Olympic Forest Coalition

COMMENTS ON STUMPY'S RIDE TIMBER SALE 30-88353; FPA 2612041

Map 1. ...Stumpy's Ride units 1-4, year of stand origin, and NSO structural habitat.

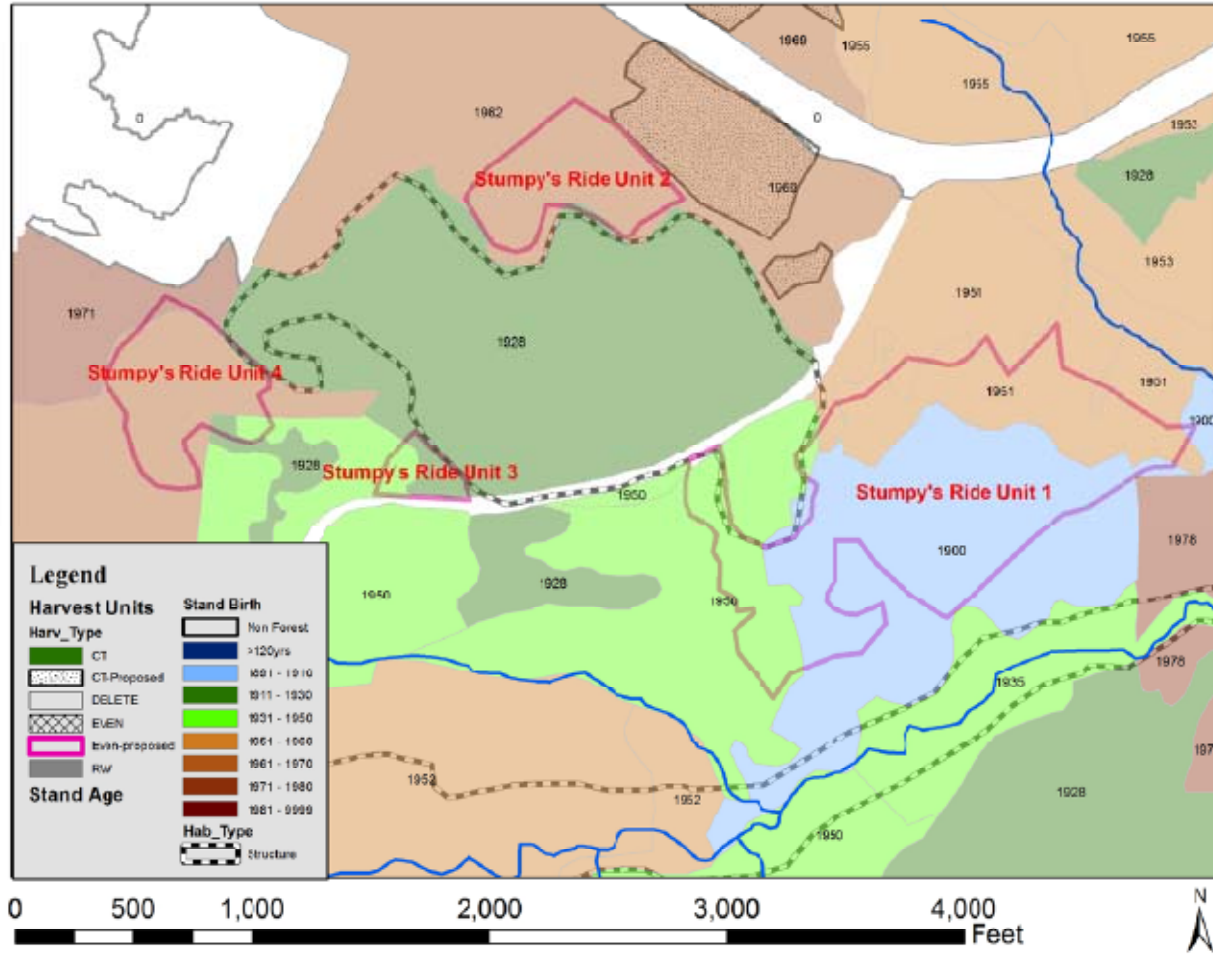
UNIT 1 HABITAT: See maps 1-4

OFCO's GIS work shows Unit 1 to be approximately 32.3 acres. Of that 18 acres are older forest (age unknown but inferred to be around ca. 1900). An additional 9.7 acres is from around 1951 (DNR mapped 1948); this is the area that shows a high density of larger, older trees in the 1957 aerial photo. All of this 9.7 acres is currently mapped as low quality adjusted habitat [MM science team database]. The remaining 4.5 acres is from 1950 (based on OFCO's Charley Creek stand age dataset). Please see Maps 1 through 4.

OFCO has found the habitat descriptions and/or mapping units are inconsistent with field and aerial photo evidence. The heart of the unit is a mature, old hemlock stand with no evidence of prior clear cutting. Substantial blocs of timber adjacent to the unit on the South and East have similar stand characteristics, except for having more old of other species than hemlock. These adjacent stands, as well as the leave trees within the unit, will be impacted by the increased exposure to wind, potentially resulting in windthrow following the harvest.

Unit 1 contains a significant amount of old, never harvested habitat, which is identified in the checklist as 112 years old. A substantial number of trees are significantly older than this. This stand may currently meet the requirements for marbled murrelet (MM) habitat or be close to it. It also may meet the requirements for northern spotted owl (NSO) habitat of some kind, or be close to it. If it is close, but lacking some characteristics on some acres, it becomes a good candidate for decadence work such as snag creation. A new inventory of the stand and its characteristics is needed to see, if it has reached habitat condition for MM or NSO or whether a decadence treatment would be needed to reach NSO habitat condition. These determinations are related to making a full and accurate implementation of the Settlement Agreement. If after a new inventory this unit is in fact at least Young Forest Marginal or better, it would require protection under PR 14-004-120.

Unit 3: See map 1

This unit is small and it abuts mapped structural habitat. A little more than half of this unit was classified as having a stand birth date of 1928 (based on OFCO mapping). It is unclear how it was differentiated from adjacent structural habitat, or whether it should in fact be considered part of the adjoining stand.

Map 5. Big Country 2006 and adjacent structural habitat

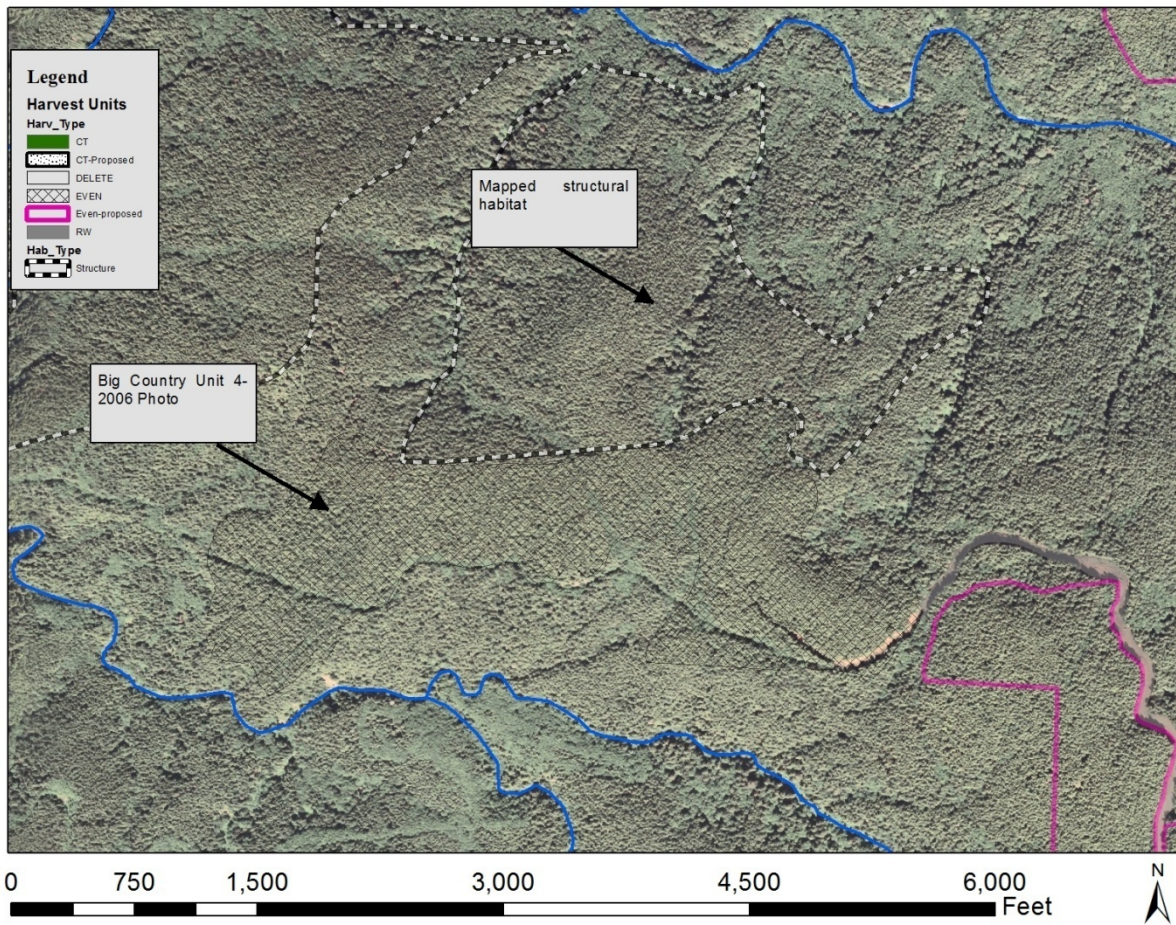
Another risk to MM and NSO habitat comes from locating regeneration harvests close to designated habitat.. There appears to be the potential of blow down on old habitat adjacent to Units 1, 2, 3, 4 and 5. A recent example of this is Big Country. Big Country included the regeneration logging of structural habitat which was then remapped to include non-structural habitat. It also involved massive blowdown of adjoining structural habitat, and potentially a second entry into structural habitat for salvage. There were huge direct and indirect habitat losses with this sale. Refer to blowdown risk under Unit 1 above.

Maps 6 & 7. Big Country 2011 and adjacent blowdown in structural habitat

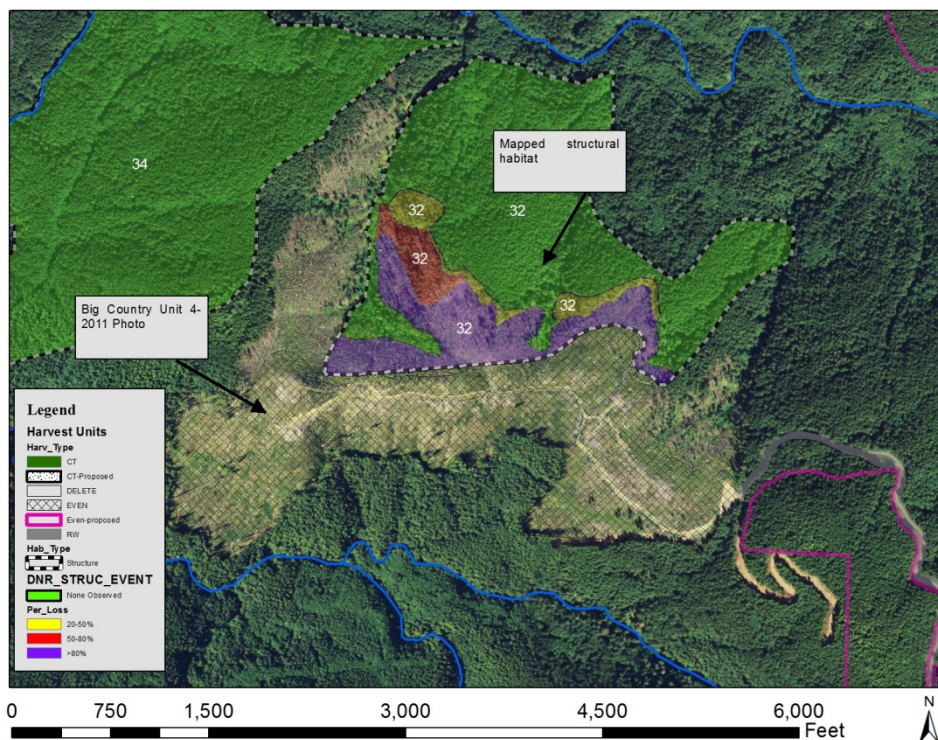
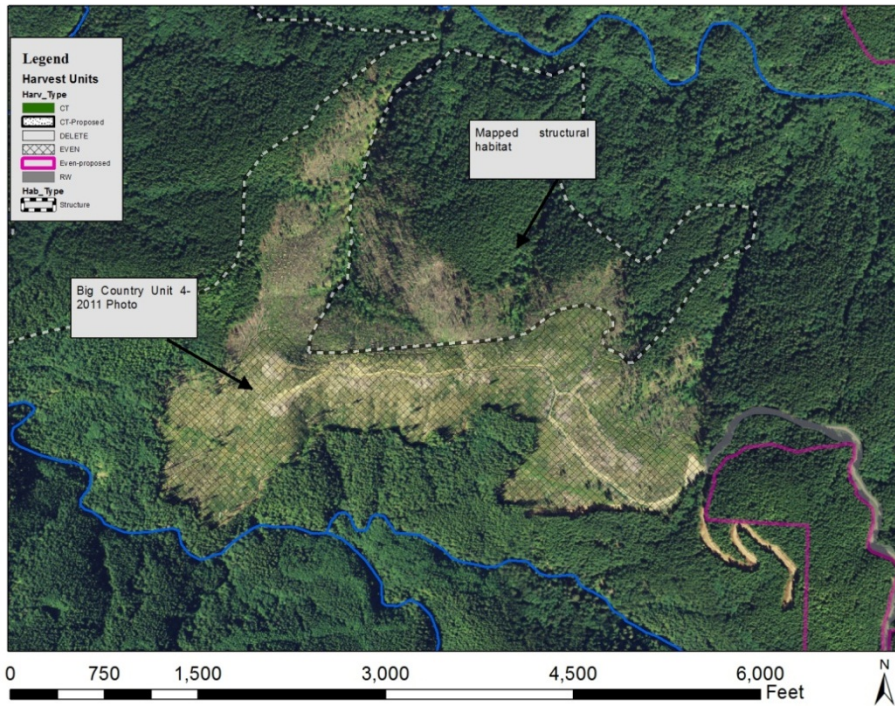
We are seeing blocks of habitat with regeneration harvest nearby. The currently existing Structural Habitat has lost an average of 15% due to blow down according to OFCO's analysis of
